# Access Compliance Report

## Public Rights-of-Way

Intersection ID: 21073	Main Street: COLONY_RD	Cross Street: SHARON_VIEW_RD	Location: SE
ADA ID: 7124FED4A192	Ramp Type: PerpDiag	Initial Pass/Fail: Fail	Overall Compliance: No
		Severity Score: 22.5

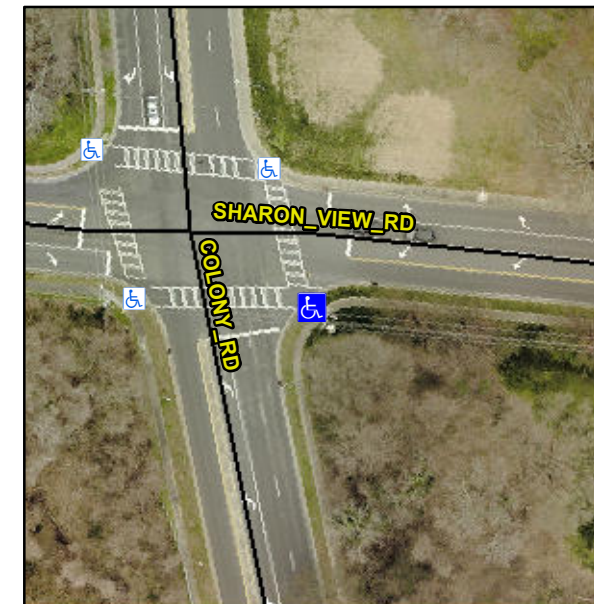
**R304.5.1, R304.2.2, R304.5.3**

Compliance	Description	Data	Compliance	Description	Data
N/A	Ramp Length (in)	71.0	No	Ramp Slope (%)	10.5
No	Ramp Width (in)	38.0	No	Ramp XSlope (%)	4.3
N/A	Flare Type LT	N/A	N/A	Flare Type RT	N/A
N/A	Flare Slope LT (%)	N/A	N/A	Flare Slope RT (%)	N/A
N/A	Flare Traversable LT?	N/A	N/A	Flare Traversable RT?	N/A
N/A	Landing Length (in)	N/A	N/A	DWS Provided?	N/A
N/A	Landing Width (in)	N/A	N/A	DWS Contrast?	N/A
N/A	Landing Slope (%)	N/A	N/A	DWS Length (in)	N/A
N/A	Landing X Slope (%)	N/A	N/A	DWS Full Width?	N/A
N/A	Landing Curb? (Y/N)	N/A	N/A	DWS Offset (in)	N/A
N/A	Shared Landing?	N/A			
N/A	Gutter Ponding?	N/A	N/A	Gutter Slope (%)	N/A
N/A	Gutter Lip Ht (in)	N/A	N/A	Gutter X Slope (%)	N/A
N/A	Painted X Walk1?	Yes	N/A	Painted X Walk2?	Yes
	X Walk 1 Direction	To N		X Walk 2 Direction	To W
N/A	X Walk 1 Width (in)	106.0	N/A	X Walk 2 Width (in)	117.0
	X Walk 1 Slope (%)	1.5		X Walk 2 Slope (%)	4.5
	X Walk 1 X Slope (%)	3.2		X Walk 2 X Slope (%)	0.9

**Remove & Replace Curb Ramp With Two New Directional Ramps or Equivalent.**
